# INITIAL FIRE SAFETY INSPECTION REPORT

## Mega Yarn Dyeing Mills Ltd (Extension 2)

RSC ID: 24731

Date: 18 December, 2023

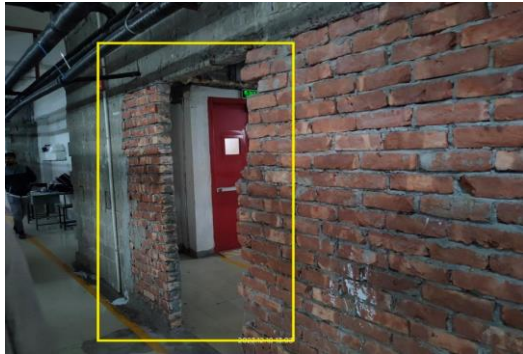
SI No.	Category	Findings	Required Action	Remediation Time Frame
F-1	Fire Rated Construction	<p>The exit stairs are not separated from work areas by fire rated construction due to unprotected opening, improper fixing of door frame &amp; door accessories were found missing . Moreover, door, frame &amp; accessories documents were not available. Stair enclosure fire wall was 1-hr rated.</p> <p style="text-align: center;"><b>Location: Building-12</b></p>	<p>Provide minimum 2-hr rated fire wall and 1.5-hr fire rated doors for buildings that are 4 or more stories. Seal all unprotected openings to separate the exit stairs from work areas and other building spaces on all floor levels. Ensure that the fire doors are self-closing and positive latching and that they are provided with fire exit (panic) hardware where serving production floors. If fire doors are required to be held open for functional reasons, provide automatic closing devices tied to the fire alarm system.</p> <p>Fire door shall install as per manufacturer guidelines. Clearance under the bottom of a door shall be a maximum of 3/4in. (19 mm). Product datasheet, certificate shall keep available at site for fire door, frame &amp; accessories.</p>	Within 3 Months

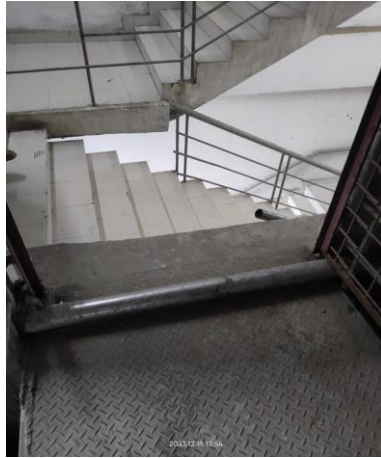
F-12	Fire Rated Construction	<p><b>Building-12</b> has some portion &amp; stair supports compressor room are constructed by steel which is non-rated and were found in exposed condition without any fire protection.</p>	<p>The building shall be type-I or II construction as per RSC Technical Guidelines (Standard) 3.5.2. Provide require rating in the structural elements of the building. Consult with a qualified fire protection engineer.</p> <p>Submit the proposed drawing/design to RSC for review. Once reviewed, install passive fire protection as per reviewed design.</p>	Within 6 months
------	-------------------------	--	--	-----------------

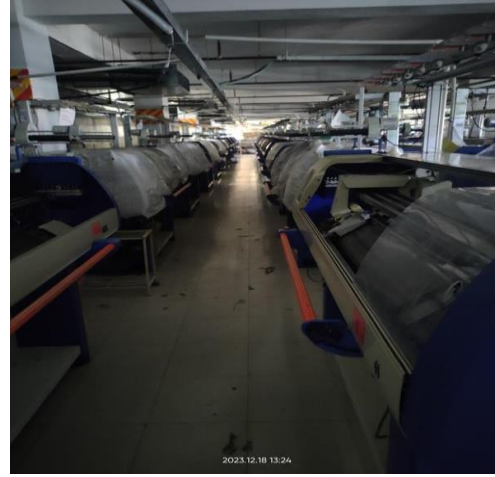
F-20	Means of egress	<p>Exit stairs serve more than 5 stories and do not have required re-entry provisions.</p> <p><b>Location: Building-12</b></p>	<p>Every door in a stair enclosure serving more than 5 stories shall be provided with re-entry unless it meets RSC standard 6.8.3.1.</p>	Within 3 months
F-21	Egress Lighting	<p>Based on the number and location of emergency lights observed, adequate illumination levels are not anticipated along egress routes.</p> <p><b>Location: Building-12</b></p>	<p>Test the emergency lighting system on each floor and provide additional emergency fixtures to provide adequate illumination along the means of egress. Provide a minimum illumination of 10 lux at the floor level within exit stairs and exit discharge paths and minimum 2.5 lux along exit access aisles.</p>	Within 3 Month

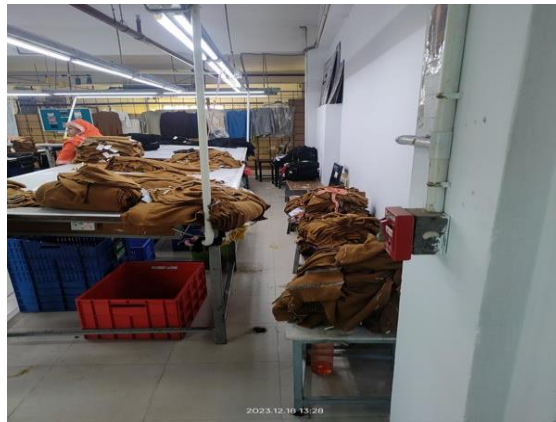
F-22	Means of Egress	<p>Aisles mark were found missing on several locations throughout the building.</p> <p><b>Location: Building-12</b></p>	<p>Provide minimum aisle widths of 36-in. Aisles mark shall be clearly visible.</p>	<p>Within 1 Month</p>
------	-----------------	---	---	-----------------------

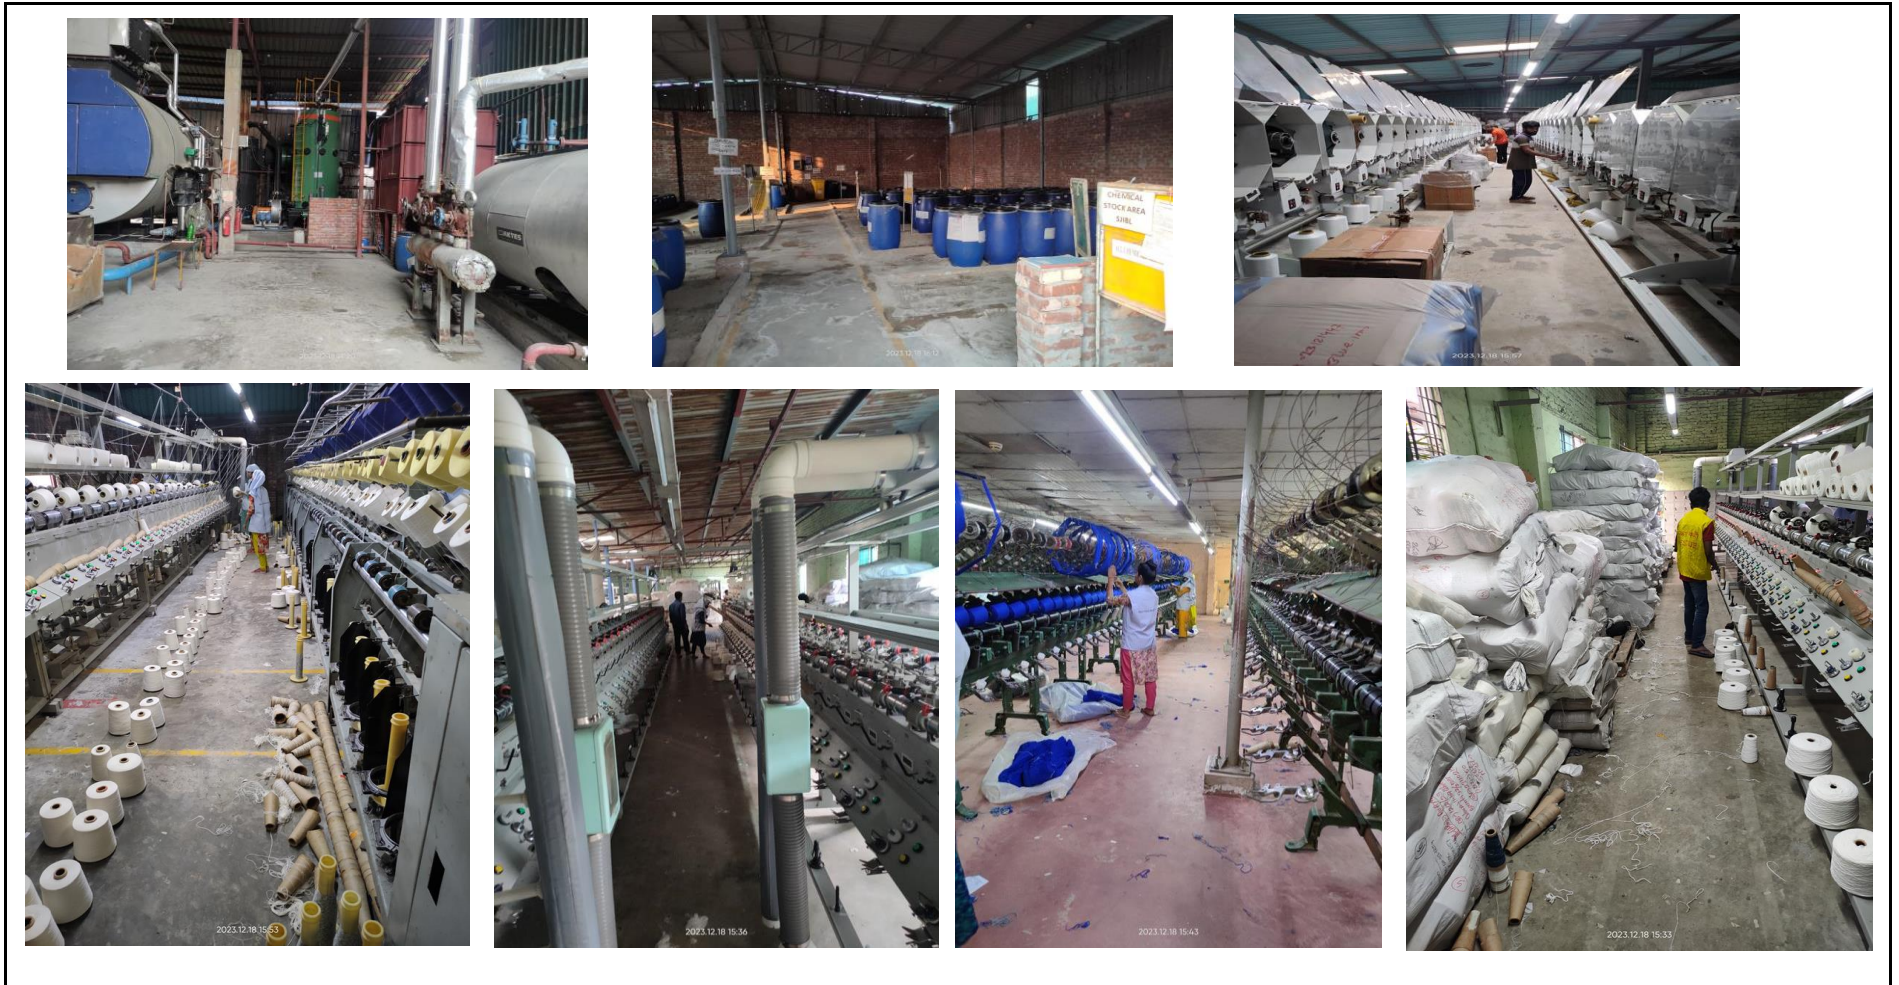
F-23	Means of Egress	<p>Aisles mark were found missing on several locations throughout the building.</p> <p><b>Location: Building 13 to Building 24</b></p>	<p>Provide minimum aisle widths of 36-in. Aisles mark shall be clearly visible.</p>	<p>Within 1 Month</p>
------	-----------------	--	---	-----------------------

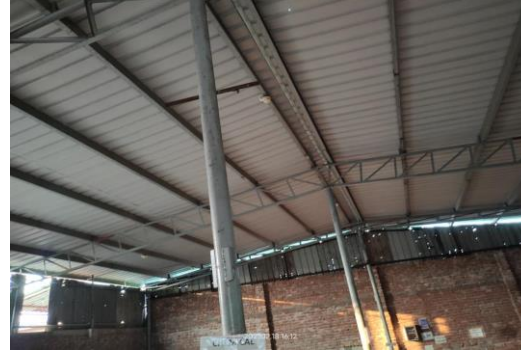
F-29	Fire Rated Construction	<p>Chemical store on Building-18 is Interim construction &amp; not Type-1 building as per BNBC - 2006.</p> <p><b>Location: Building -18</b></p>	<p>The building shall be type-I as per BNBC 2006 Table 3.2.4. Provide require rating in the structural elements of the building. Consult with a qualified fire protection engineer.</p> <p>Submit the proposed drawing/design to RSC for review. Once reviewed, install passive fire protection as per reviewed design.</p>	Within 6 Months
------	-------------------------	---	---	-----------------

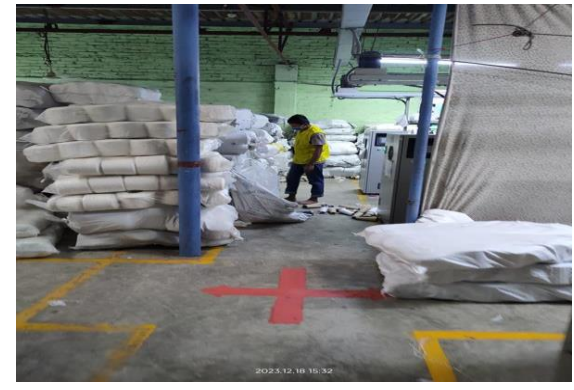
F-30	Fire rated Construction	<p>Areas used for combustible storage open to the factory are not maintained or separated by fire rated construction.</p> <p><b>Location: Building 14,15, 19</b></p>	<p>Separate the dedicated storage rooms by minimum 1-hr fire-rated construction. Provide 0.75 hr. fire rated door and seal all penetrations and openings by 1 hr. fire rated fire rated barrier construction.</p> <p>Where separate storage rooms are not feasible, provide defined storage areas and limit the storage arrangement as follows: -</p> <ul style="list-style-type: none"> <li>- Maximum height of 2.45m (8ft.) , maximum area of 23m<sup>2</sup> (250 ft<sup>2</sup>) and 3m (10ft.) clear distance from adjacent another unenclosed combustible storage.</li> <li>- If the building/floor is sprinkler protected: maximum height of 3.66m (12ft.) and maximum area of 93m<sup>2</sup> (1000 ft<sup>2</sup>).</li> <li>-In process storage shall be limited to 10 percent of the building area of the story in which they occur.</li> </ul>	Within 3 months
